**Colorado Springs, CO
Planning and Development**

Final Report - Corrections Required
Application No. DEPN-23-0002

Description : proposing to build (4) 3-story apartment buildings with clubhouse and pool

VETERANS VICTORY - LOT 1 DEVELOPMENT PLAN

PRELIMINARY UTILITY & PUBLIC FACILITIES PLAN

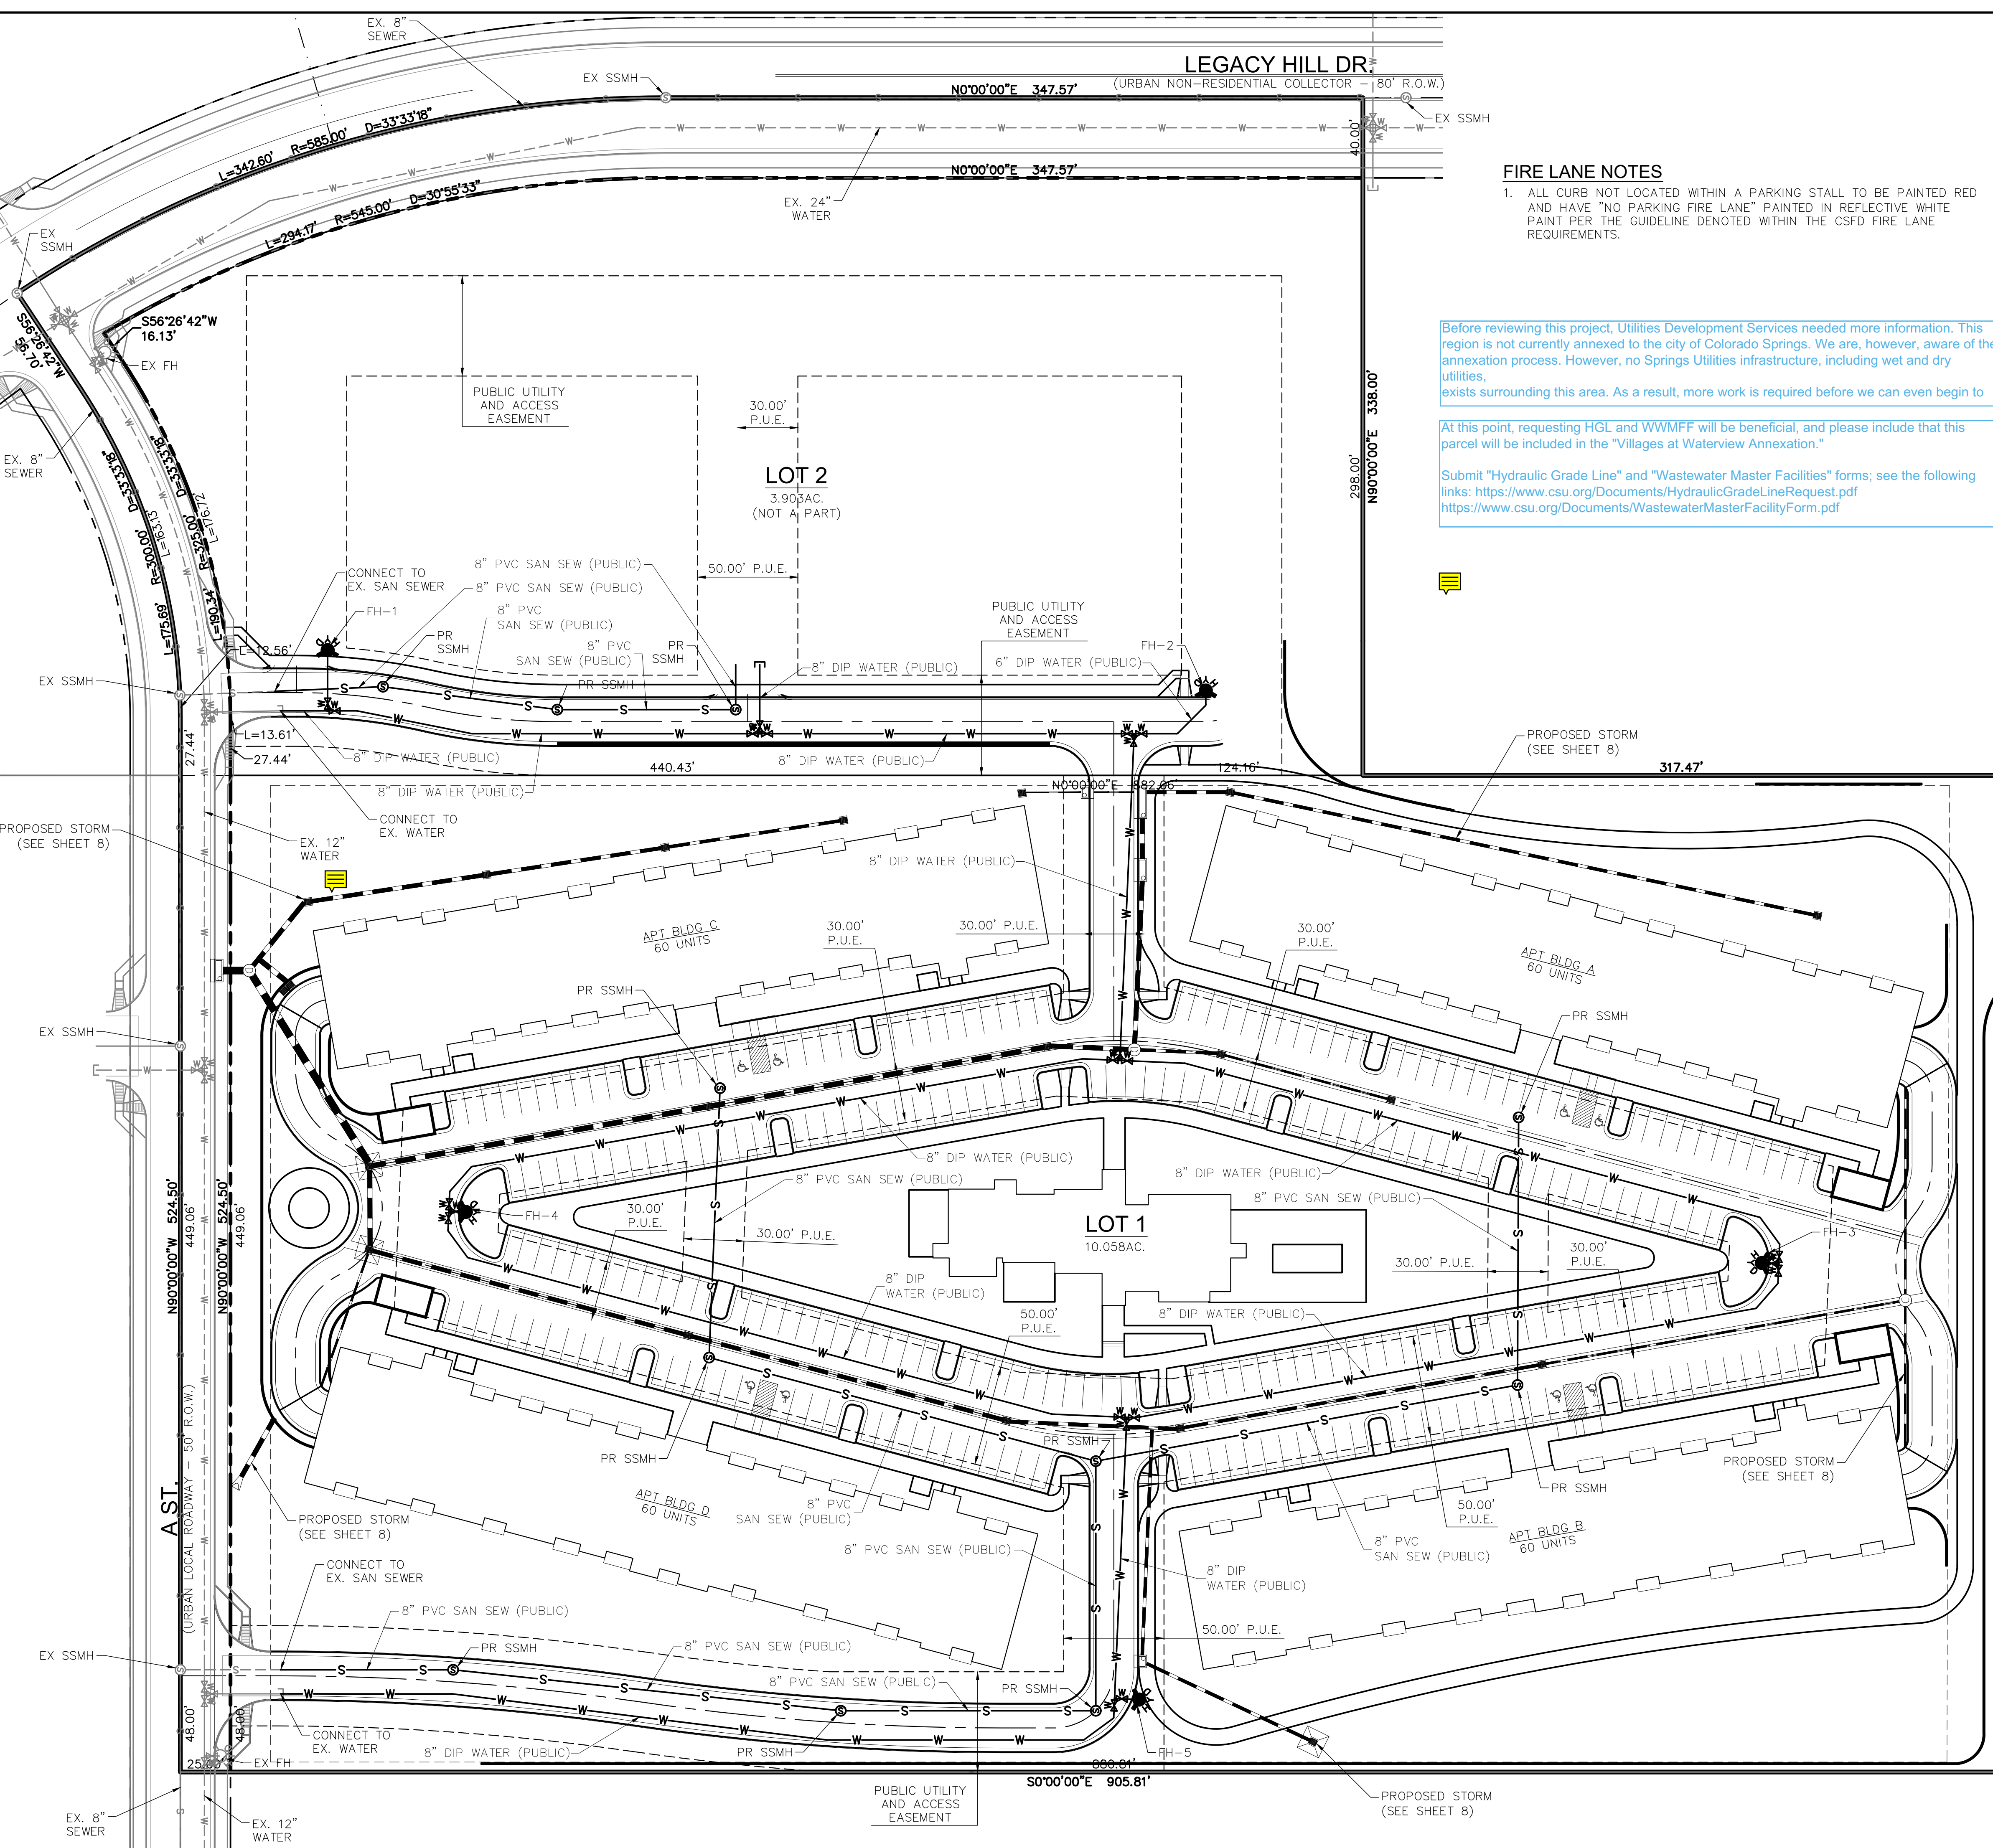
Before reviewing this project, Utilities Development Services needed more information. This region is not currently annexed to the city of Colorado Springs. We are, however, aware of the annexation process. However, no Springs Utilities infrastructure, including wet and dry utilities, exists surrounding this area. As a result, more work is required before we can even begin to
